**Superfund Five Year Review Report
Benfield Industries Site, Waynesville, NC
EPA ID: NC981026479**

**FINAL SUPERFUND FIVE YEAR REVIEW REPORT
BENFIELD INDUSTRIES SITE
EPA ID: NC981025479**

**Prepared By the
US Army Corps of Engineers
Nashville District**

August 2003

Figure 5. Groundwater Conc.-BaP

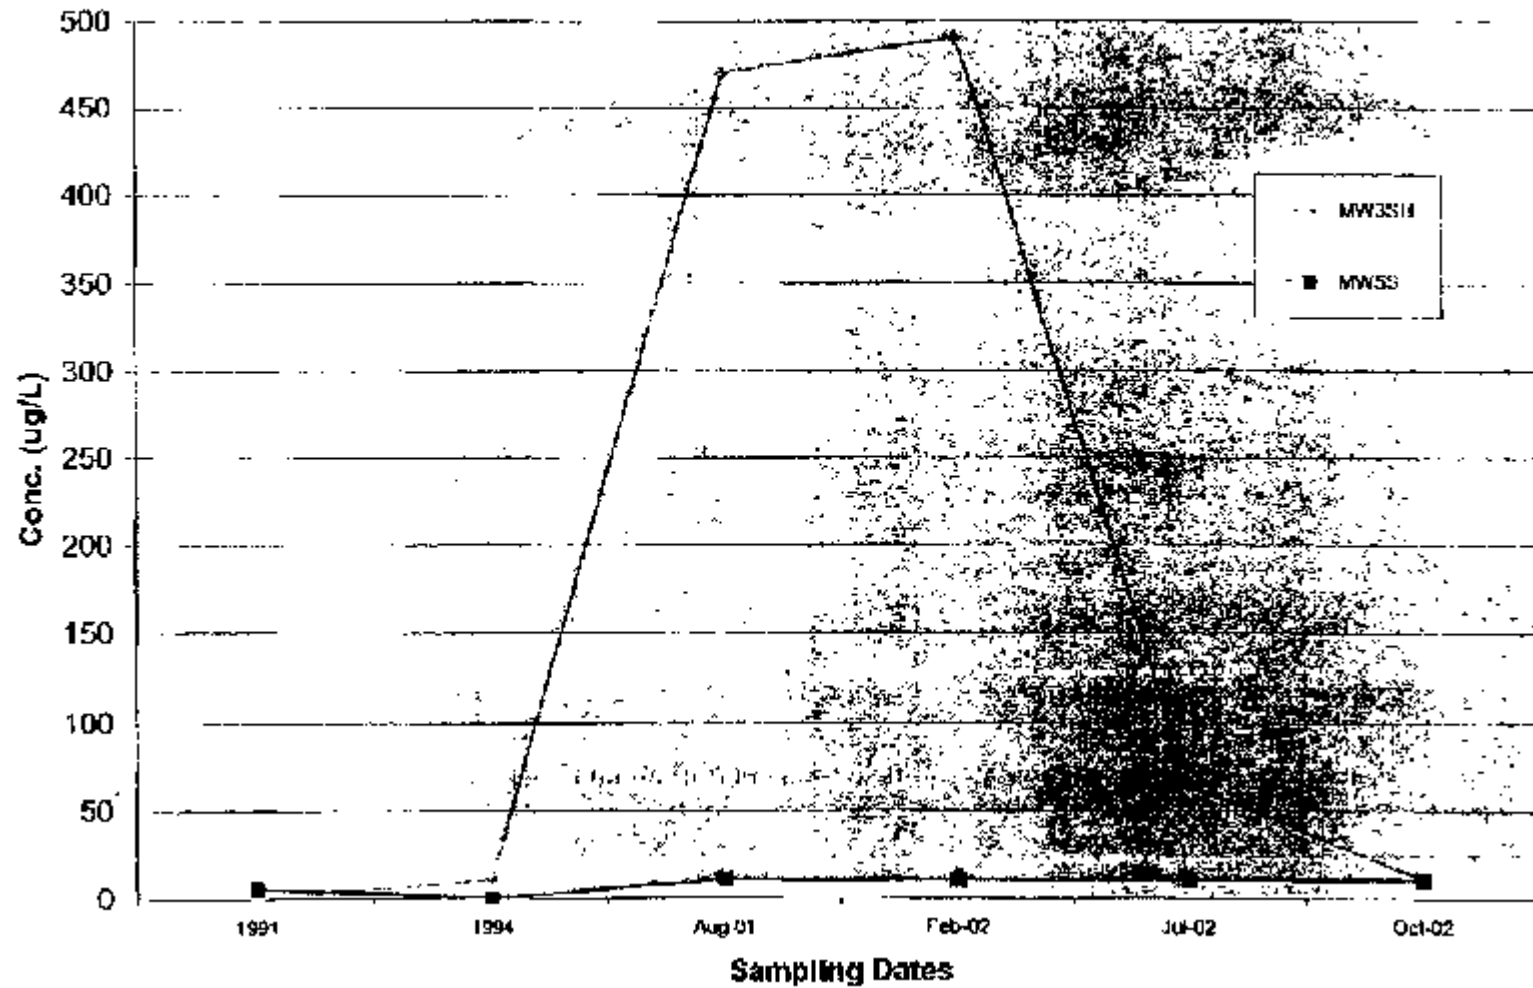
In general, **Figures 3 through 8** show that concentrations of these “risk drivers” has decreased in all wells since Site remediation in 1994. However, BaP concentrations (**Figure 5**) appear to have increased above the remediation level (0.2 ug/L) between 1994 and July 2002 before decreasing again in October 2002. In addition, Mn (**Figure 8**) appears to be on the increase in all three of these wells since August 2002. In the most recent sampling event (October 2002), concentrations of these contaminants were below remediation levels (“RL” on plots), with the exception of Mn in all three wells. The reduction of metal concentrations could be a direct result in a change in sampling technique. A bailer was utilized to collect samples prior to October 2002. For the October 2002 and for all subsequent sampling events a low flow sampling technique was used. This technique usually produces samples with lower turbidity and thus could be responsible for the lower metals concentrations.
